20.0 REQUIREMENTS RESULTING FROM FUKUSHIMA NEAR-TERM TASK FORCE RECOMMENDATIONS

This chapter addresses the requirements resulting from the Fukushima Near-Term Task Force (NTTF) recommendations that are applicable to the Levy Nuclear Plant (LNP) Units 1 and 2 Combined License (COL). The applicable recommendations address four topics: a reevaluation of the seismic hazard (related to Recommendation 2.1), mitigation strategies for beyond-design-basis external events (related to Recommendation 4.2), spent fuel pool (SFP) instrumentation (related to Recommendation 7.1), and emergency preparedness staffing and communications (related to Recommendation 9.3).

Figure 20.1-4. CEUS SSC Model Charleston RLME Sensitivity to Rupture Orientation at the Savannah Test Site at 1 Hz (top) and 10 Hz (bottom)
(NUREG-2115 Figures 9.3-1 and -2)

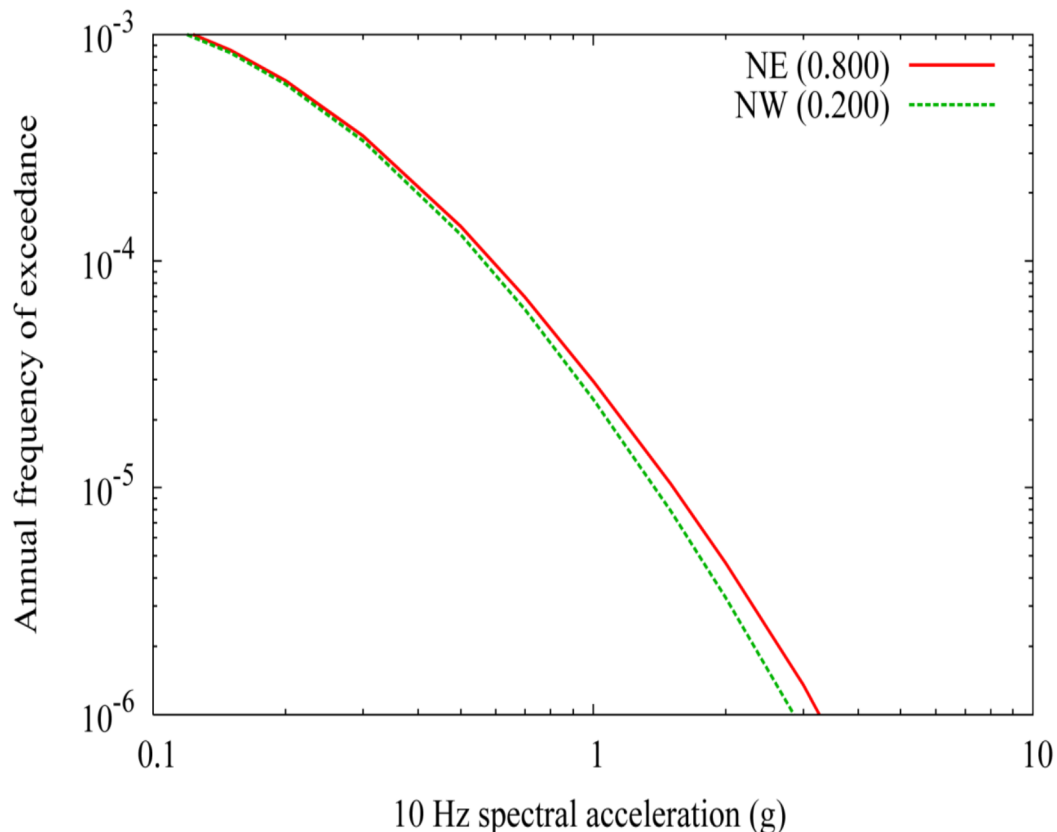
NUREG-2115 includes the results of a sensitivity analysis showing that, at a 10^{-5} annual exceedance frequency when both fault rupture orientations are modeled, the percent difference between the weighted mean average hazard and the northeast orientation is less than

5 percent, indicating that mean hazard at Savannah is not significantly affected by having two alternative rupture orientations for the Charleston regional source. SER Figure 20.1-4 shows the difference in hazard between modeling of the two alternative fault rupture orientations. Because the difference between the hazard using the two orientations is not large and the northeast orientated fault ruptures are weighted 0.80 in this source's final hazard results, the northeast orientated fault ruptures dominate the weighted mean average hazard at the Savannah test site. Therefore use of only the northeast orientated fault ruptures would result in hazard calculations within 5 percent of using both fault rupture orientations.

The applicant performed sensitivity calculations for the LNP site using a model with northeast ruptures weighted 0.8 and northwest ruptures weighted 0.2 for the Charleston regional source geometry. The applicant's sensitivity calculations showed that hazards for the 10⁻⁴ and 10⁻⁵ annual exceedance frequencies at 1 Hz spectral accelerations are approximately 0.04 percent lower than those presented in FSAR Figure 2.5.2-340. The applicant stated that it chose to run the sensitivity calculations at 1 Hz because, for the LNP site, the hazard at this spectral frequency is dominated by the contributions from the Charleston RLME source. Therefore, 1 Hz would be the best frequency at which to perform the sensitivity calculations because the effect

LNP site hazard calculations using the CEUS SSC model. As shown in SER Figure 20.1-2, the Charleston and Reelfoot Rift RLMEs are the closest RLME sources to the LNP site, and both lie beyond the LNP Site Region. The applicant's sensitivity study showed a 0.04 percent change in the CEUS SSC uniform hazard response spectra (UHRS) because of the Charleston RLME sensitivity to rupture orientation at the LNP site. The NUREG-2115 sensitivity calculations showed a less than 5 percent difference in hazard at the Savannah site because of the Charleston RLME sensitivity to rupture orientation. Given these findings, the staff concludes that the applicant's use of only the northeast orientation for the Charleston RLME regional source with a weight of 1.0 adequately characterizes the hazard from the Charleston RLME regional source at the LNP site.

Figure 20.1-6. Comparison of Mean and Fractile Hazard at the Chattanooga Site Computed by the Applicant ("This Study") and Reported in NUREG-2115 (FSAR Figure 2.5.2-326)

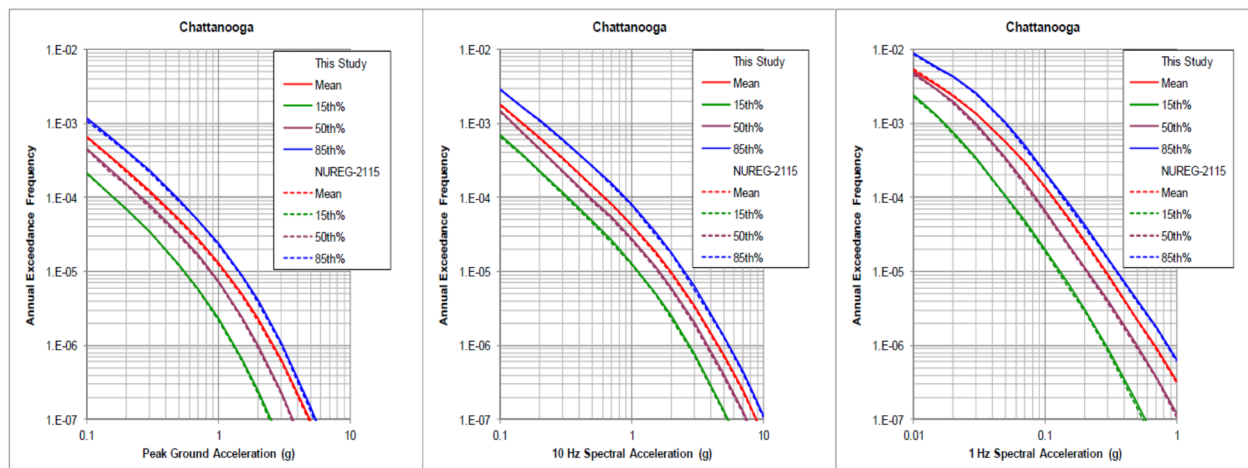
As shown in SER Figure 20.1-1, the Savannah site is the closest CEUS SSC test site to the LNP site. Second, the Chattanooga site is comparable to the LNP site because the Chattanooga site is located at a similar distance from the Charleston RLME source as the LNP site. The Chattanooga site is approximately 547 km (340 mi) from the Charleston RLME source, and the LNP site is located at a distance of approximately 482 km (300 mi). The staff considers the Savannah and Chattanooga sites to be the test sites applicable to the LNP site. Consistent with the applicant's analysis, the percent difference between the applicant's calculation and that of NUREG-2115 spectral acceleration values calculated at the Chattanooga site show less than a 3 percent difference at annual frequencies of exceedance of 10^{-4} , 10^{-5} , and 10^{-6} at 1 Hz, 10 Hz, and peak ground acceleration (PGA). The staff does not consider this to be a significant difference in ground motion values. SER Figure 20.1-6 shows the applicant's closely matched calculation to the Chattanooga test site mean and fractile hazard curves.

Figure 20.1-7. Comparison of Mean and Fractile Hazard at the Savannah Site Computed by the Applicant ("This Study") and Reported in NUREG-2115
(FSAR Figure 2.5.2-330)

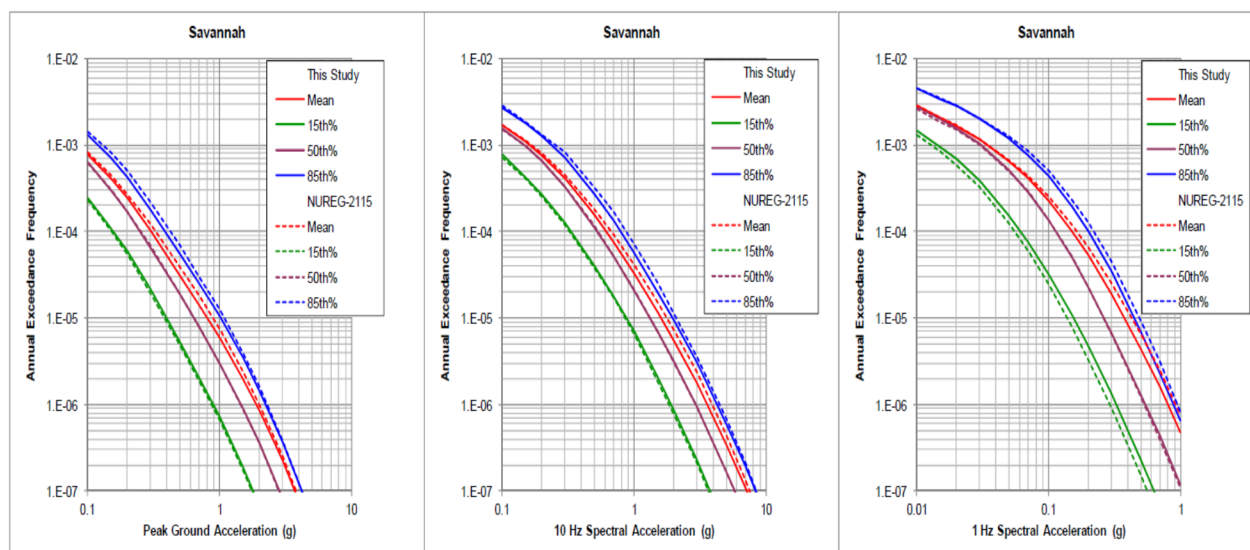
The percent differences at the Savannah site, however, are larger and range between 5.3 and 13.1 percent. SER Figure 20.1-7 shows the results graphically. These percent differences are the only values that rise above the applicant's generalized assessment of "values are generally less than 5 percent". The applicant attributes the differences to implementation details of modeling the large-magnitude rupture locations for sites near the Charleston RLME sources, where the Savannah site is located 128 km (80 mi) southwest of the Charleston RLME sources. As described in SER Section 2.5.2.7.2.6, the applicant tested two implementation methods for modeling the Charleston RLME at the Savannah test site: (1) A series of closely spaced pseudo faults parallel to the northeast orientation of the zone and earthquake ruptures were modeled as occurring uniformly along these faults, and (2) the source zone was filled with a grid of uniformly spaced points and at each point magnitude-dependent ruptures were placed with the specified northeast orientation with a random location on the grid point.

According to the applicant, when method (1) was compared with method (2), the effect of using method (2) was that the model increased the probability of rupture locations near the boundary. This alternative process, method (2), produced acceptable results in comparison with those presented in NUREG-2115 using method (1). In a letter dated October 15, 2012 (ADAMS Accession No. ML12291A857), the applicant stated it used implementation method (1) in its hazard calculations for the LNP site. From testing the two implementation methods, the applicant concluded that the differences in modeling the Charleston RLME source have minimal impact on the computation of the mean hazard at larger distances, such as at the LNP site, as evidenced by the applicant's ability to reproduce the hazard at the Chattanooga test site

Figure 20.1-9. Comparison of Hard Rock UHS Based on Updated EPRI-SOG and CEUS SSC models
(FSAR Figure 2.5.2-340)

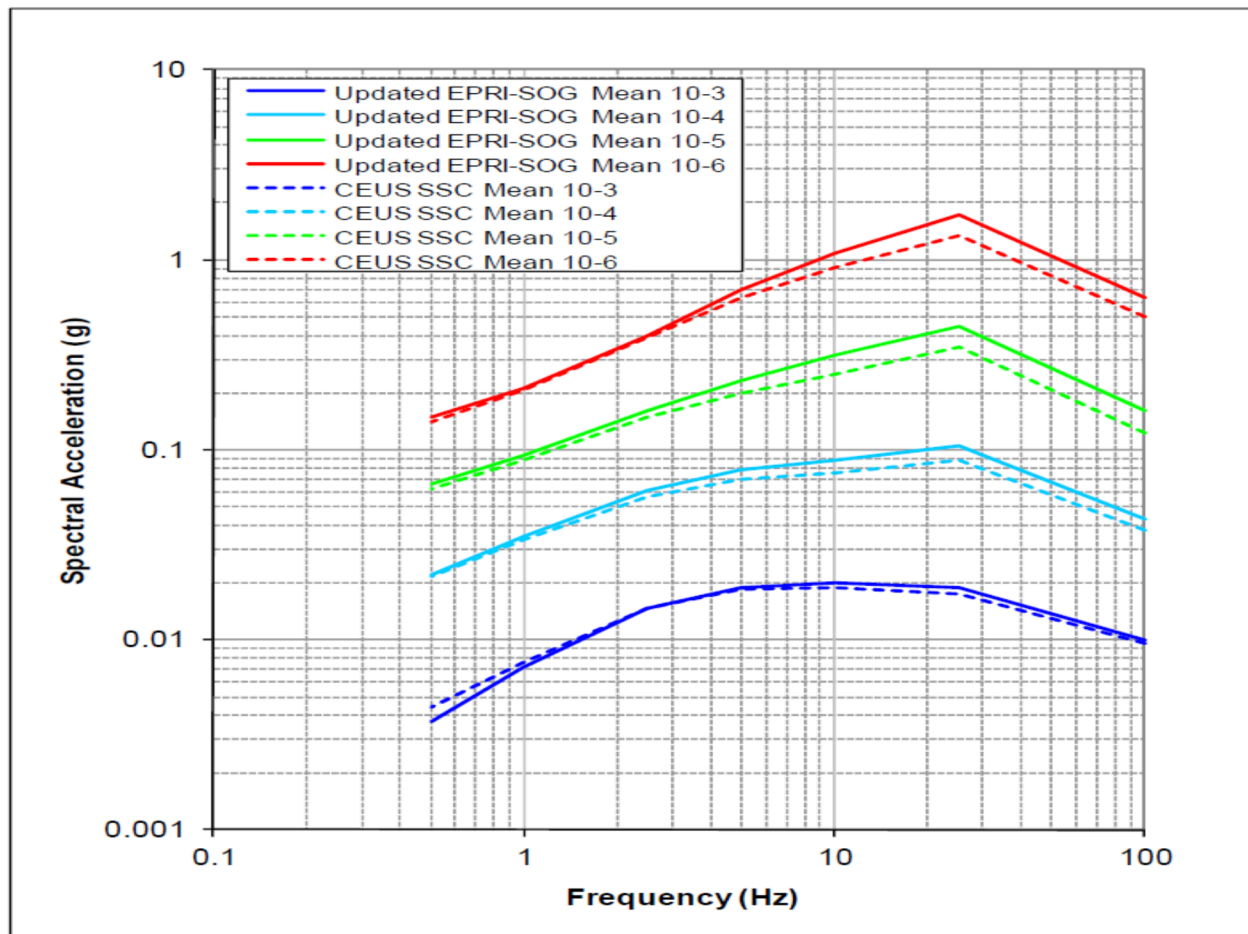
SER Figure 20.1-9 shows the applicant's hard rock UHRS. The UHRS based on the CEUS SSC model are lower than those based on the updated EPRI-SOG model at spectral frequencies greater than 2.5 Hz and higher at low frequencies for the 10^{-3} mean annual exceedance frequency. However, the EPRI-SOG UHRS for the 10^{-4} and 10^{-5} mean annual exceedance frequencies, which are used to calculate the GMRS, are higher than those from the CEUS SSC at all frequencies shown.

The staff reviewed the applicant's calculation of the GMRS. Based on the similarity of the spectral shapes of the UHRS calculations using the CEUS SSC model and the updated EPRI-SOG model (SER Figure 20.1-9) and the similarity of the UHRS deaggregation results (SER Figure 20.1-10), the staff concludes that it is not necessary for the applicant to recalculate the LNP site amplification functions. The staff also concludes that the previously developed site amplification functions are appropriate for use with the CEUS SSC calculations.

Figure 20.1-10. Comparison of 10^{-4} Deaggregation Results from EPRI SOG (left) and CEUS SSC (right) Models
(FSAR Figures 2.5.2-240 and 2.5.2-342)

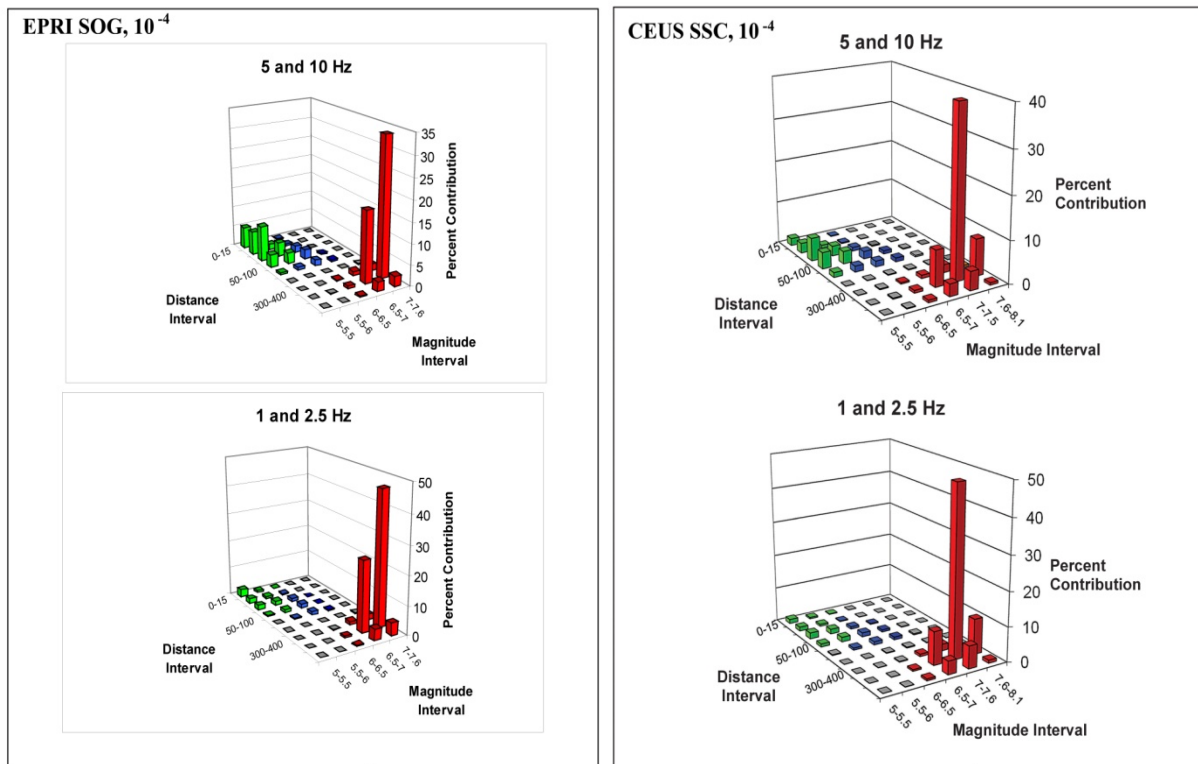
Following calculation of the UHS, the applicant deaggregated the spectra consistent with RG 1.208 to determine the controlling earthquakes. FSAR Figures 2.5.2-341, -343, and -344 show the deaggregation results for mean annual exceedance frequencies of 10⁻³, 10⁻⁵, and 10⁻⁶, respectively. SER Figure 20.1-10 shows the deaggregation results for the 10⁻⁴ mean annual exceedance frequency using the CEUS SSC model compared to those using the EPRI-SOG model. The applicant demonstrated that the deaggregation results are similar to those for the updated EPRI-SOG hazard results, as seen in SER Figure 20.1-10.

The staff also conducted an independent confirmatory analysis of the hard rock hazard and UHS at the LNP site. The staff calculated the hazard using the CEUS SSC model (NUREG-2115) for distances up to 750 km (469 mi) for distributed seismicity sources and 1,000 km (621 mi) for RLME sources. In its confirmatory analysis, the staff used the EPRI 2004-2006 ground motion attenuation model (same as the applicant). The staff's calculations of the 10⁻⁴ and 10⁻⁵ UHS are enveloped by the applicant's calculations. Because the UHS

results and the total hard rock hazard curves developed by the staff are in good agreement with those developed by the applicant, the staff finds the applicant's PSHA acceptable.

The staff evaluated the applicant's determination of the hard rock UHRS and deaggregation results. Since the applicant used a method to determine the UHRS that was consistent with the calculation in FSAR Section 2.5.2.4 and guidance in RG 1.208, the staff concludes that the applicant properly calculated its hard rock UHRS. Finally, the comparison of the deaggregation results (SER Figure 20.1-10) shows that, as expected, the earthquakes controlling the spectra are similar when using either seismic source model.

Figure 20.1-11. Comparison of GMRS Based on Updated EPRI-SOG and CEUS SSC Models.
(FSAR Figure 2.5.2-355)

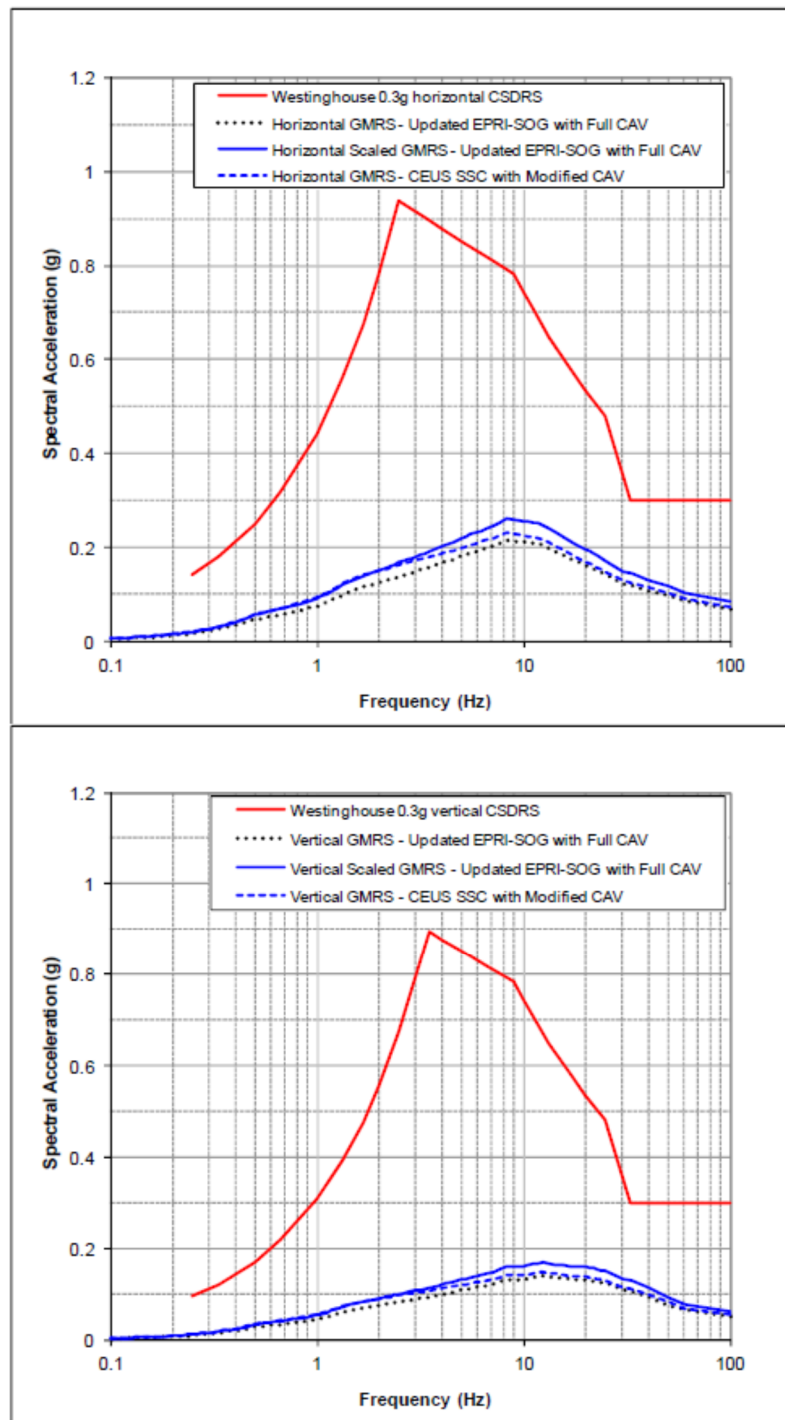
SER Figure 20.1-11 shows the applicant's GMRS, which was calculated using the CEUS SSC model, the updated CAV methodology, and the previously determined site amplification functions. The applicant determined the GMRS from the UHRS using relationships described in RG 1.208. RG 1.208 guides applicants to calculate the GMRS using the following relationship:

In SER Figure 20.1-11, the horizontal and vertical GMRS using the CEUS SSC model is compared to the GMRS using the updated EPRI-SOG model and the AP1000 certified seismic design response spectra (CSDRS). The applicant presented percent differences between the GMRS in FSAR Table 2.5.2-234. The GMRS based on the CEUS SSC model is enveloped by the GMRS based on the updated EPRI-SOG model, except for frequencies between 0.2 and 2 Hz where the CEUS SSC-based GMRS is up to 4 percent higher. However, the GMRS calculated using the CEUS SSC approach combined with the updated CAV filter methodology resulted in higher amplitudes of response spectra than calculations based on the EPRI-SOG approach combined with the original CAV filter application presented in the LNP COL revisions 1 through 4. To address this issue, the applicant revised the original GMRS calculations presented in LNP COL revisions 1 through 4 by applying a 1.212 scaling factor to the original GMRS. This scaled GMRS is presented in Section 2.5.2.6 of FSAR Revision 5 in the LNP COL application and is described in SER Section 2.5.2.6. The 1.212 scaling factor is consistent with the scaling factor applied to the foundation input response spectra (FIRS) in compliance with the 10 CFR Part 50, Appendix S, "Earthquake Engineering Criteria for Nuclear Power Plants," requirement that the horizontal component of the FIRS in the free-field at the foundation level of the structure be an appropriate response spectrum with a minimum PGA of 0.1g.
